PRODUCT: AUTOMATED CATWALKS

DATE: Mar 20, 2008

SUBJECT: TRANSFORMER POLE GUARD

SERIAL NUMBERS: ALL PC2000's, PC3000's, PC4000's, TM80 AND TM120 HPU's

WITHOUT GUARD INSTALLED

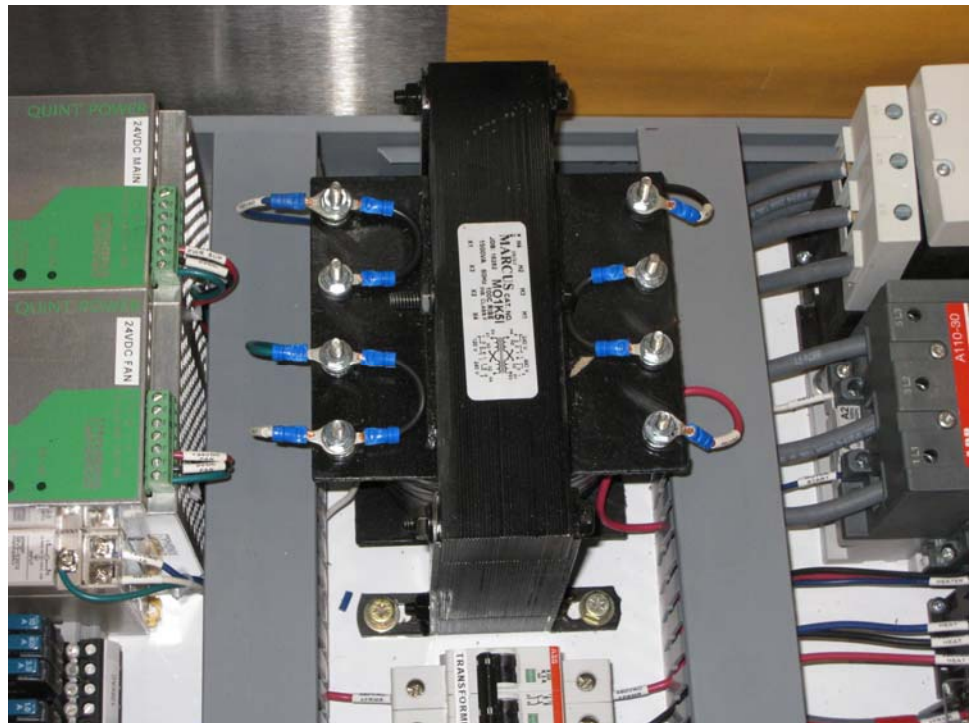
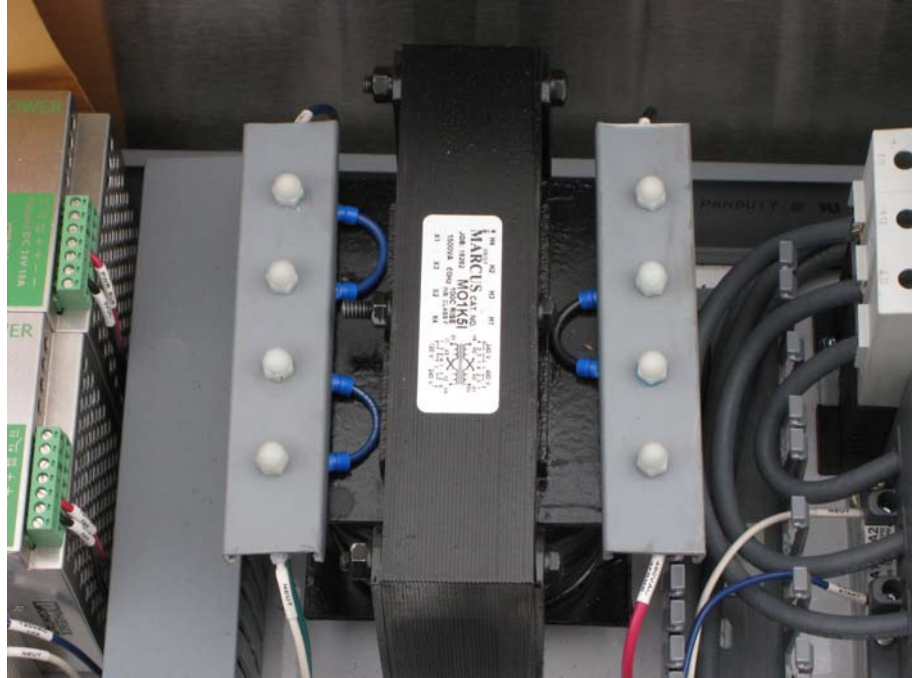
DISCUSSION: Service personnel are exposed to high voltage due to the exposed poles on the control transformer when opening the main PLC panels.

Install kit number AY50485 which consists of a (2) guards and nylon acorn nuts to insulate anyone accessing the main PLC panel.

******CAUTION****** When installing the kit ensure power to the PLC panel is disconnected at the MCC.
